Work Order ID 71816

Item Name: Crosstube Turning Detail

DART AEROSPACE LTD	Work Order: 71814
Description: Crosstube Assembly	Part Number: D407-667-245
Inspection Dwg: D407-667-245 Rev: F	Page 1 of 1

DRAWING NO. D407-667-245	TITLE CROSSTUBE ASSY (407 HIGH AFT)	REV. F	DART AEROSPACE LTD ENGINEERING ORDER		D.E.O. NO. D407-667-245-F-1	SHEET NO. SHEET 1 OF 2	SCALE NTS
DRAWN <i>J</i>	CHECKED <i>JP</i>	MFG. APPR. <i>E</i>	APPROVED <i>140</i>		DE APPR. <i>H</i>		
DATE 11.04.08	DATE 11.04.12	DATE 11.04.12	DATE 11.04.12		DATE 11.04.12

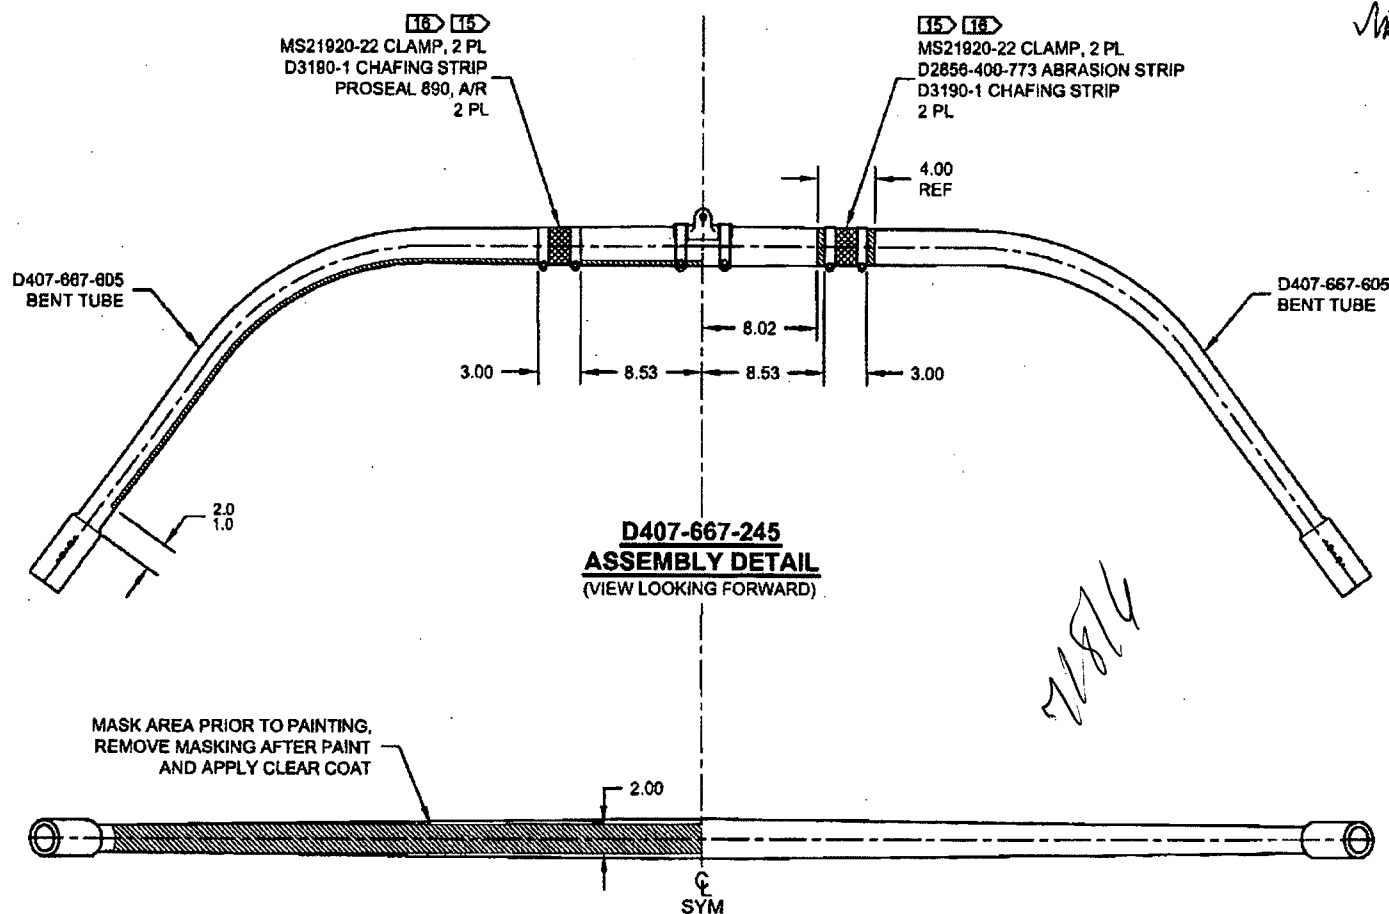
PURPOSE:

REMOVED ABRASION STRIP IN FAVOR OF A THIN LAYER OF PROSEAL 890.

NOTES 2 AND 15, SHEET 1 ARE AMENDED AS FOLLOWS:

- 2) FINISH: CHEMICAL CONVERSION COAT PER DART QSI 005 4.1
PRIME INSIDE AND OUTSIDE PER DART QSI 005 4.2
MASK UNDERSIDE OF CROSSTUBE AS SHOWN (HATCHED AREA) AND
PAINT OUTSIDE PER DART QSI 005 4.2
REMOVE MASKING AND APPLY CLEAR COAT
- 15) APPLY A THIN COAT OF PROSEAL 890 ON INSIDE CONCAVE SURFACE OF D3190-1
CHAFING SHIELDS AND LET CURE PER MANUFACTURER'S INSTRUCTIONS. INSTALL
PROSEALED D3190-1 CHAFING SHIELDS ONTO CROSSTUBE BY APPLYING A THIN COAT
OF PROSEAL 890 ONTO CROSSTUBE. BE SURE TO ELIMINATE ANY AIR GAPS.

IS:

WAS:
